RE: Response to Information Request (Section 13.2 DA Rules)

The Paint Factory Arts Village, 115 Hyde Road, Yeronga (Application Ref. A006334703)

Figure A: Comparison of lodged and amended Structure Plan

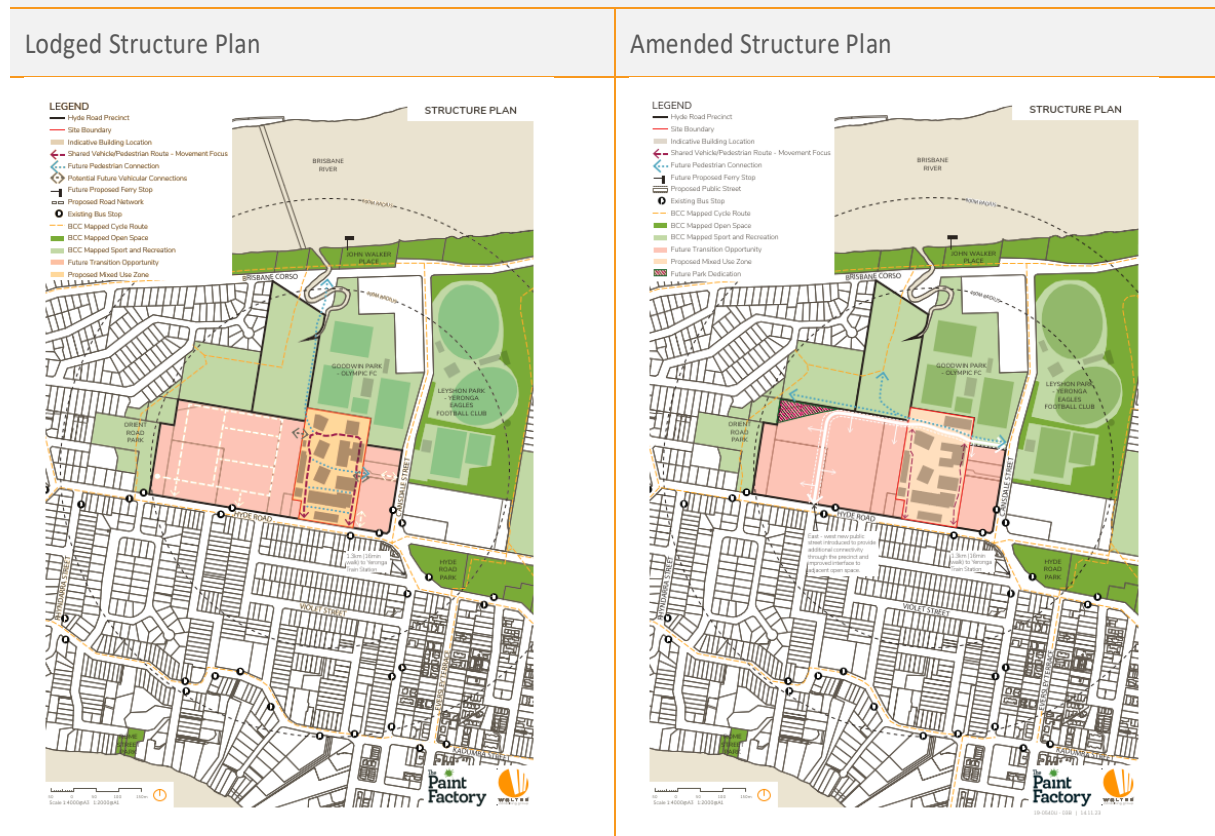
- Removal of the request to vary the effect of the Industrial Amenity Overlay and Waterway Corridor Overlay from the development application.
- Changes to the Structure Plan, Variation Plans and Master Plan including:

- A new public road orientated east-west. The purpose of this road is to connect the site and street network to adjoining properties and providing a new access point to Cansdale Street. Access from Cansdale Street to the site is required through adjoining Open Space land. A future park dedication is provided to offset the Open Space land required to connect the precinct to Cansdale Street.

- Additional open space in the western area of the broader Precinct to provide for greater stormwater and retention the waterway corridor.
- Changes to the Masterplan and Variation Plans, including:

Figure B: Comparison of lodged and amended Master Plan

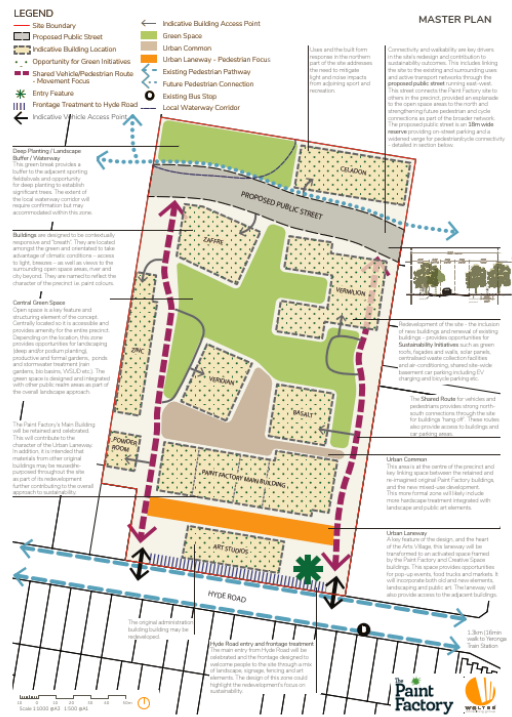
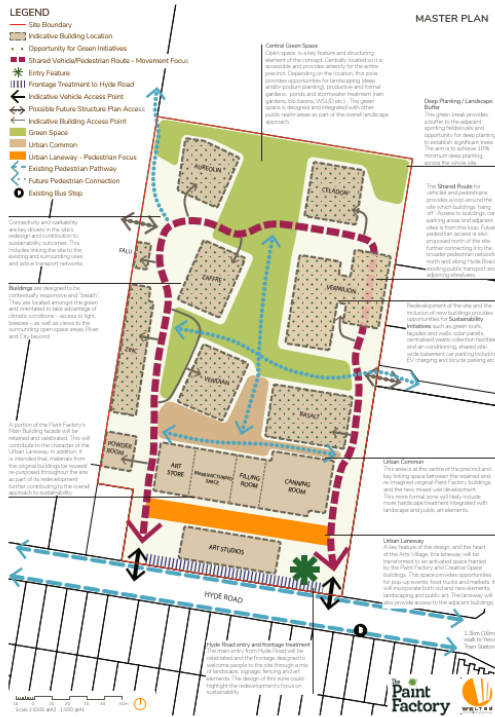
- Accessibility throughout the site and to the broader road, pedestrian and cyclist networks have been enhanced and indicated on the Structure Plan and Master Plan.

Figure D: Comparison of lodged and amended Height Variation Plan

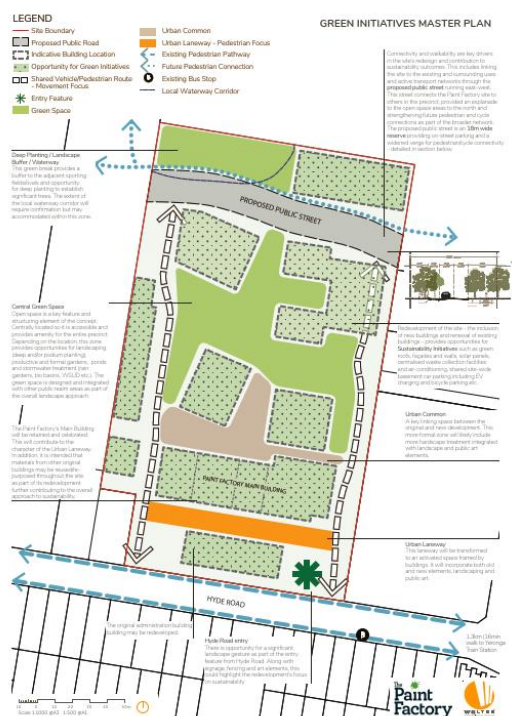
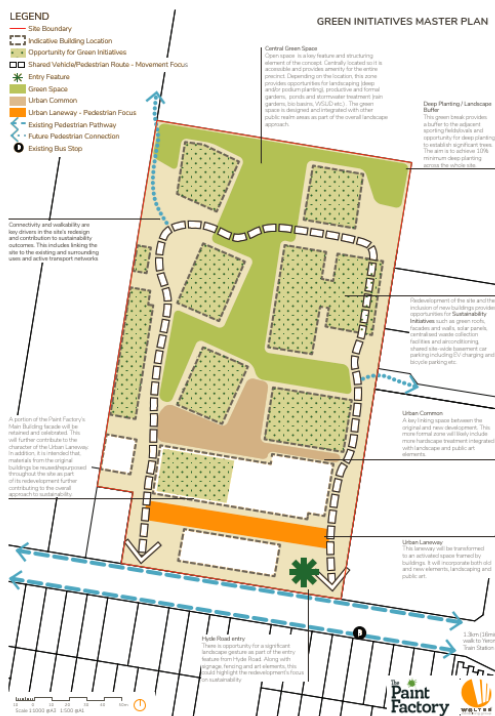
- Inclusion of a public street with an 18m road reserve as detailed in the section provided on the development application variation plans.
 - Amendments to the Height Variation Plan to provide a maximum 15m building height limit for the land north of the proposed public street. This is consistent with the underlying building height prescribed by the Industry Code for land within the Low Impact Industry Zone.

Figure G: Comparison of lodged and amended Land Use Variation Plan

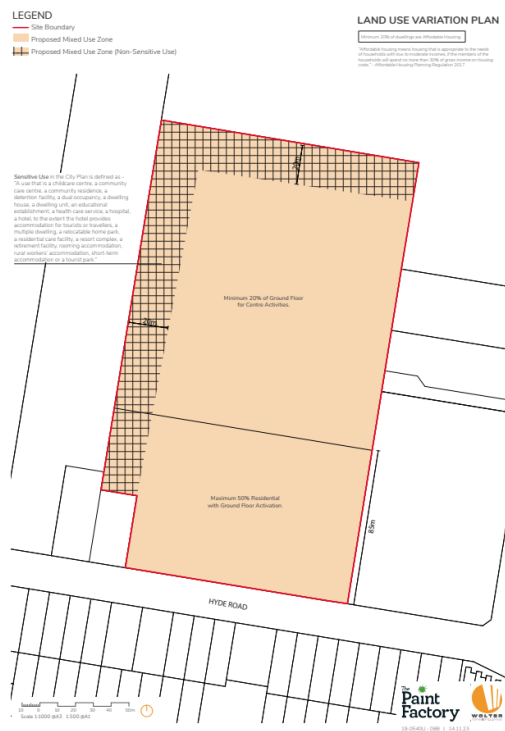
- Amendments to the Variation Plan – Land Use to provide 20m buffer to accommodate 'non-sensitive' land uses along the western and northern perimeter of the Paint Factory Site.

- The Paint Factory's Main Building façade and structure to the extent identified in the plans is to be retained, repurposed and celebrated.
 - The Land Use Variation Plan incorporates amendments that appropriately acknowledge the surrounding industrial precinct, by ensuring that non-sensitive land uses are not located within 20m of the north and western property boundary.

Figure 1 Proposed Amended Structure Plan

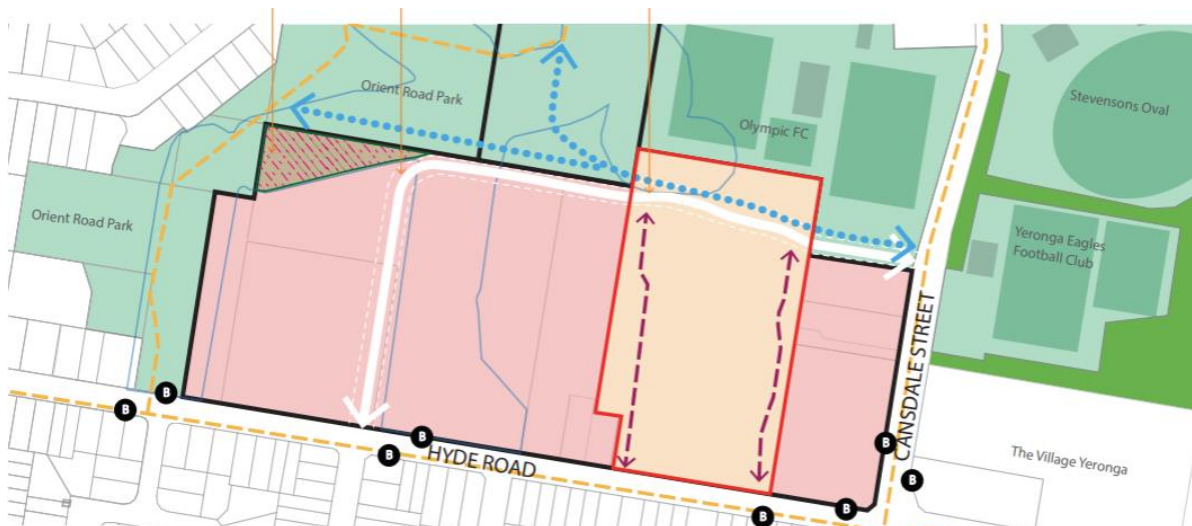
Provide an updated structure plan in accordance with the requirements of the Structure planning scheme policy (SC6.29) indicating how the proposed development will provide enhanced integration with surrounding sites and Goodwin Park. This should include precinct-wide outcomes that provide:

- a. A new public road connecting the site to adjoining properties and providing new access points to existing roads;
- b. Additional open space for stormwater management; and
- c. A land use and movement network strategy (road network, pedestrian and cyclist paths) that facilitates east / west connectivity and interfaces towards the northern boundary and park.

The Structure Plan has been amended to include:

- a new public road connecting the site to adjoining properties and providing a new access point to Cansdale Street;
- additional open space for stormwater management; and
- a land use and movement network strategy.

Figure 11 Variation Plan - Land Use
Source: Urban Context Report

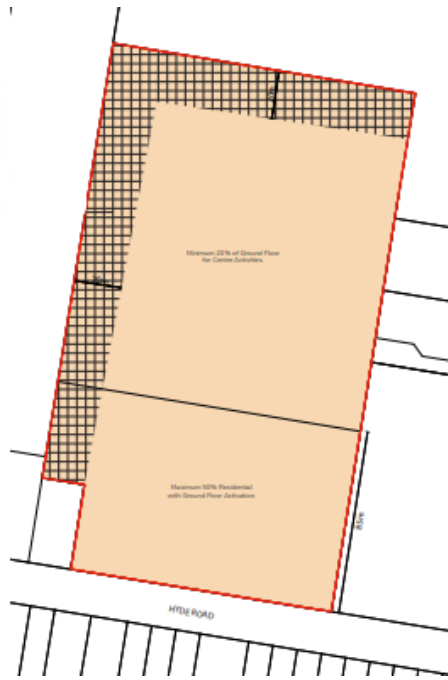
It is acknowledged that the proposal includes 20% of future dwellings to be provided as affordable housing, key worker housing and/or artist studios, however the definition of housing affordability does not appear to correspond with Planning Regulation 2017 definition of 'affordable housing'.

- a. Amend the application to align with the Planning Regulation 2017 definition of affordable housing.

The land use variation plan, has introduced a 20m buffer along the western and northern boundaries of the Paint Factory site. This will allow for an improved interface with the open space and sports facilities to the north, and also the established industrial uses to the west to avoid an adverse amenity impacts.

The definition of Affordable Housing on the Land Use Variation Plan has been amended to align with the *Planning Regulation 2017* definition.
